REGIONAL JDAP - CITY OF BUNBURY - DAP APPLICATION - DA/2022/231/1 - DETERMINATION

Property Location:	92 (Lot 33, 34, & 102) Blair Street, Bunbury
Application Details:	Motor Vehicle Wash, Fast Food Outlet with Drive Through Facility, and Pylon Signs

**Determination on Development Assessment Panel
Application for Planning Approval**

NEW SERVICE STATION COMPLEX

SOUTH ELEVATION 1:100 AT A1

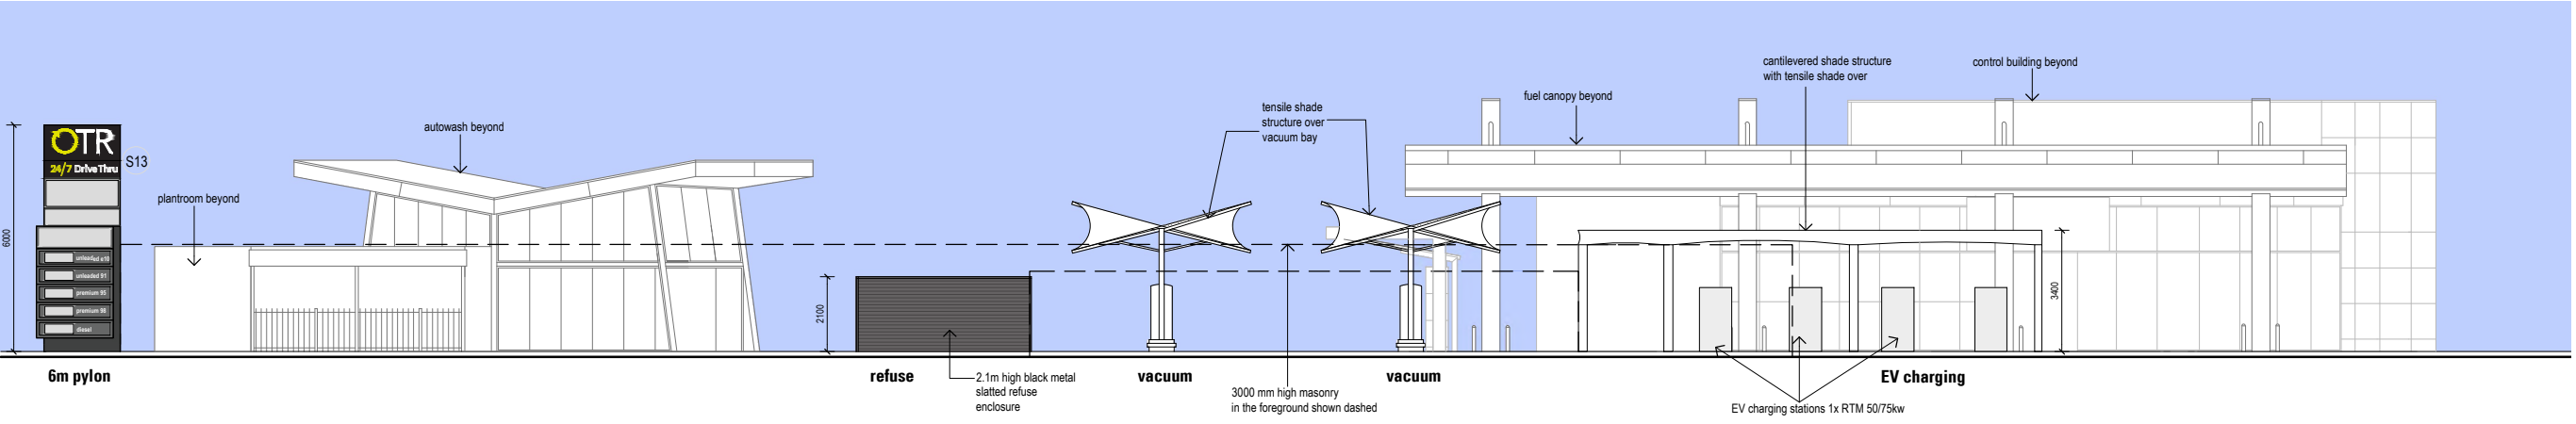
Pylon sign to be a maximum
height of 6.5m above natural
ground level

WEST ELEVATION 1:100 AT A1

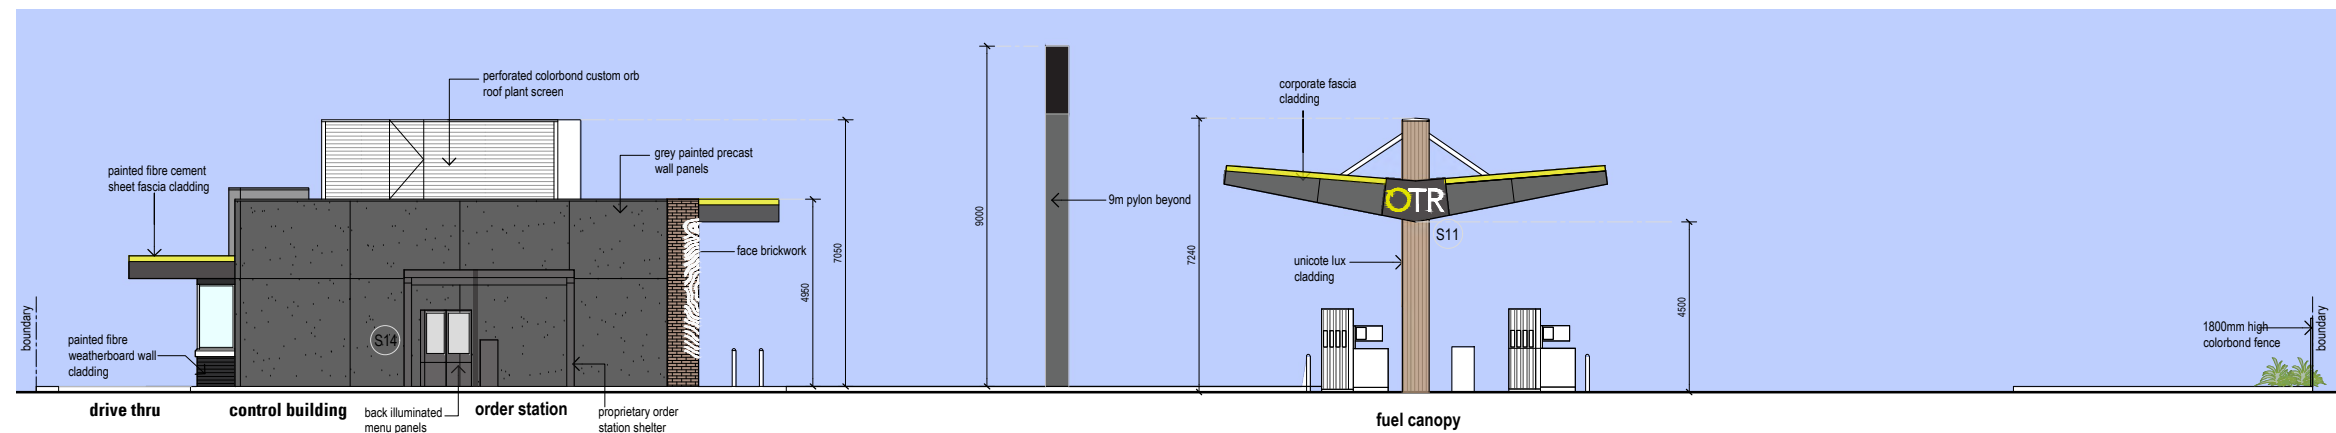
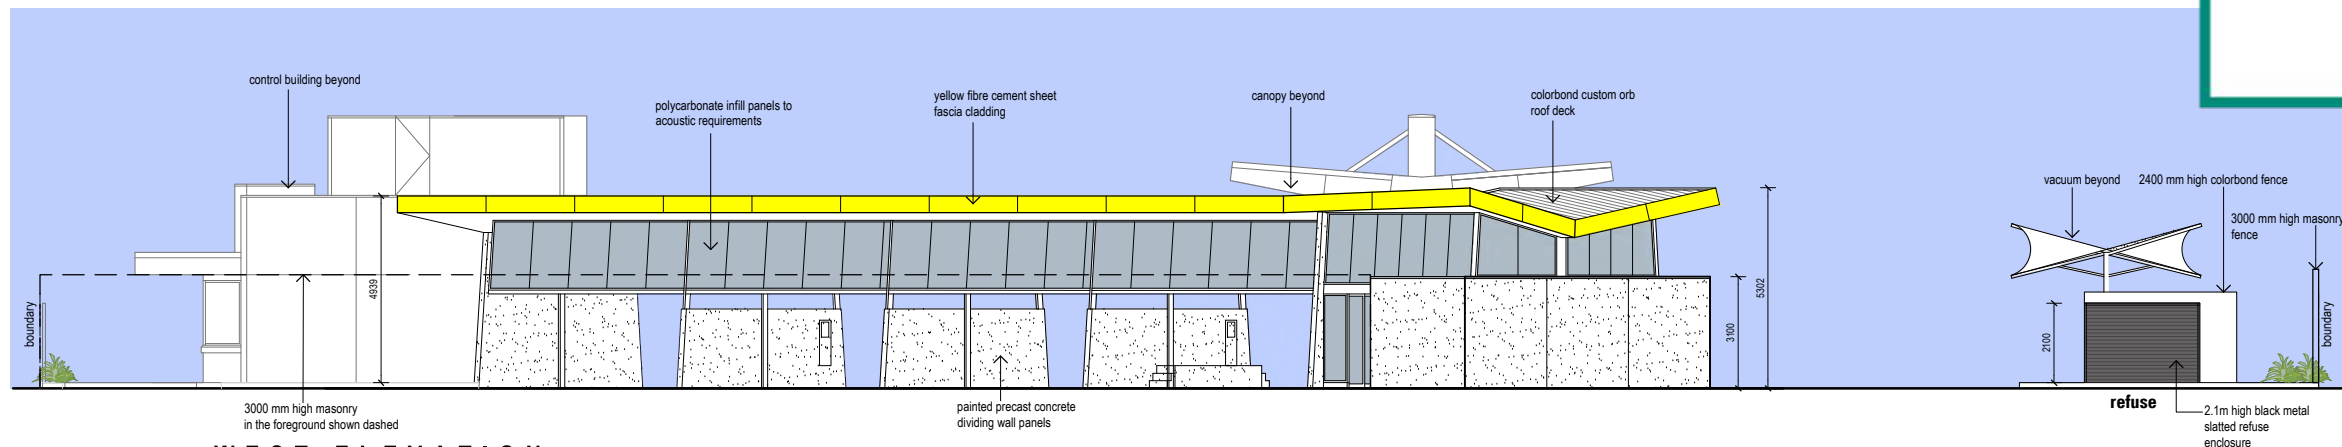
Pylon sign to be a maximum height of 6.5m above natural ground level

SIGNAGE ELEVATIONS 1:100 AT A1

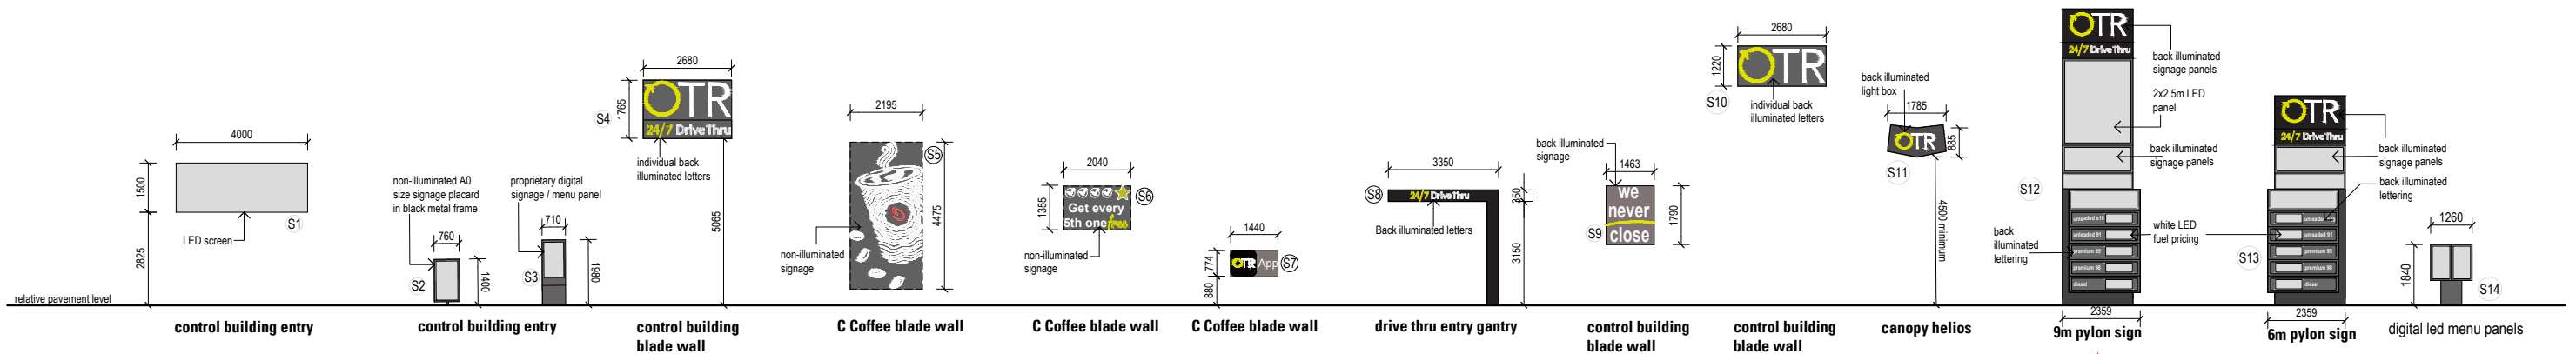
Pylon sign to be a maximum height of 6.5m above natural ground level
